PUBLIC INTEREST REVIEW FOR GROUNDWATER APPLICATIONS

TO: Water Rights Section Date 01/22/2016  
 FROM: Groundwater Section Phillip I. Marcy / Ivan K. Gall  
Reviewer's Name  
 SUBJECT: Application G- 18006 Supersedes review of 07/07/2015  
Date of Review(s)

**A. GENERAL INFORMATION:** Applicant's Name: Diamond Farms LLC County: Baker

### Water-Level Trends in Nearby Wells

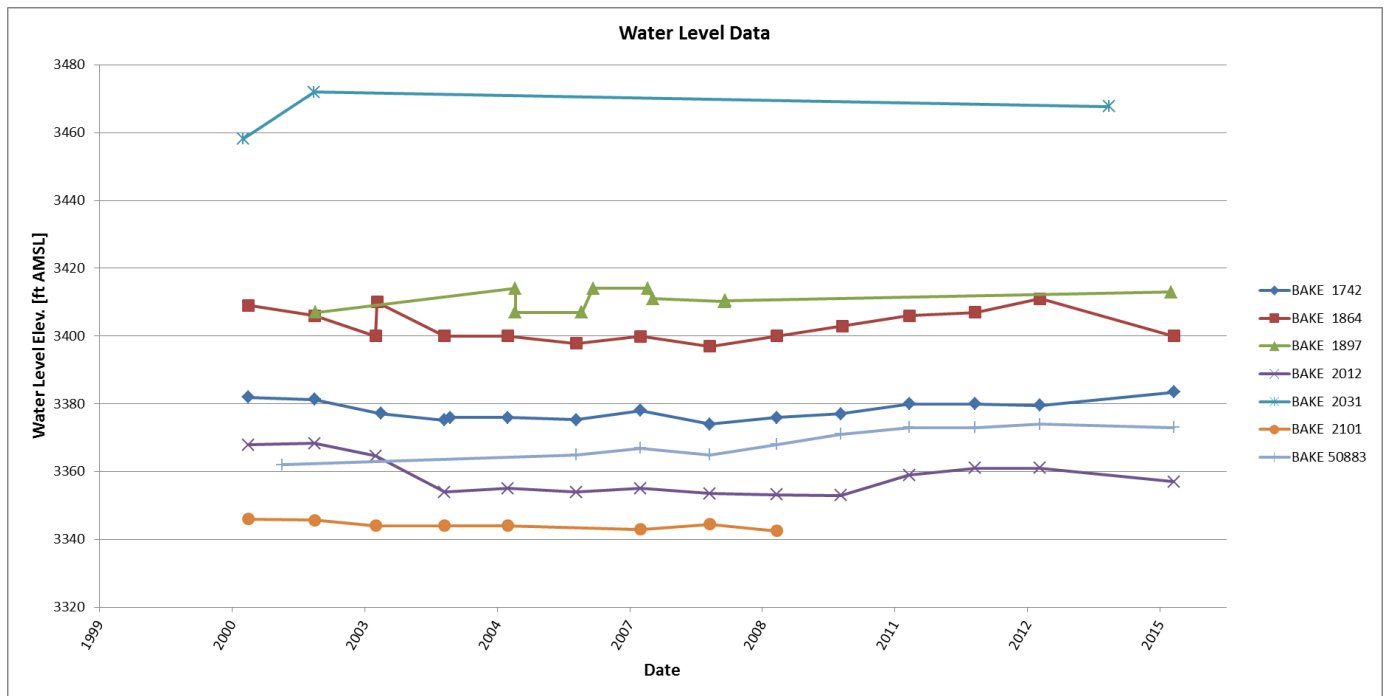
B3. **Groundwater availability remarks:** Groundwater elevations in wells within several miles to the west of the proposed POA location have remained stable since the year 2000 (see attached). These measurements were made in wells producing from alluvial wells in which basalts or other volcanic units were not encountered and so may not represent the same aquifer system as proposed on this application. The proposed POA location is within 200 feet southwest of the mapped contact with Tertiary basalt (Tb) of Brooks and others (1976) on the northeast side of a fault. Wells within 1 mile have encountered volcanic units at very shallow depths on this side of the fault (see attached log for BAKE 51823). Our current conceptual understanding is that fractured basalts at shallow depths here are hydraulically connected to alluvial fill contacted across the fault.
